**Re: Rosemont Mine Plan of Operations July 11, 2007 - Review for Completeness**

**SUBJECT: Rosemont Mine**

**RE:** PDEQ Comments on Augusta Resource Corporation's Rosemont Project Mine Plan of Operations

Figure 1) Location of Other Deposits at RP same as Figure 6-2 in 2007 Mineral Resource Update.

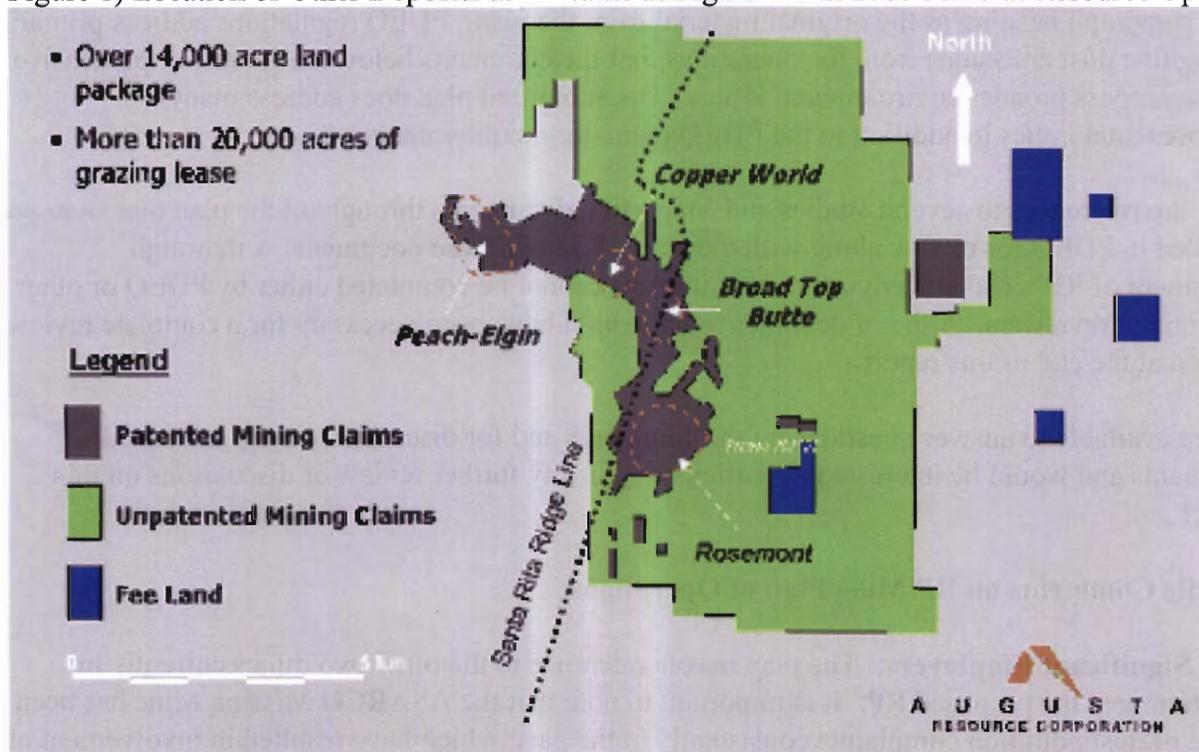
**2.1.1 Open Pit Plans:** The RP open pit configuration is stated to ultimately be "about 6,500 ft across north to south, 6,000 ft across east to west, and will be about 1,800 to 2,900 ft deep." It is understood exact pit configuration cannot be determined now due to the fluctuation in metal prices and precise information on the distribution of mineral reserves. However, PDEQ would like to see some limitations on pit size included in the document so that a guarantee is given on the allowable extent of the pit.

Review of the 2007 Mineral Resource Update for the Rosemont Project, dated April 26, 2007, revealed the presence of a total of 4 deposits on the Rosemont Property. They included the Rosemont Deposit, which ARC has planned to extract, the Broadtop Butte Deposit to the north of Rosemont, the Copper World Mine to the north and west, and the Peach-Elgin Deposit to the north and west. All three of the other deposits lie partially or completely over the ridgeline of the Santa Rita Mountains (see Figure 1 below.) Development of these potential resources in the future would lead to visual and physical impacts not addressed in the plan. In order to consider this version of the plan complete, PDEQ would need some statement incorporated that these deposits specifically will *NOT* be developed in the future, regardless of economic incentive. Incorporation of such intentions in the closure planning of the mine will be necessary to prevent sale of the other deposits to mining interests in the future. The recent complaint filed by ASARCO contesting ARC's ownership of the mine testifies to other firms' interest in the Santa Rita Range (<http://biz.yahoo.com/iw/070824/0294999.html>).
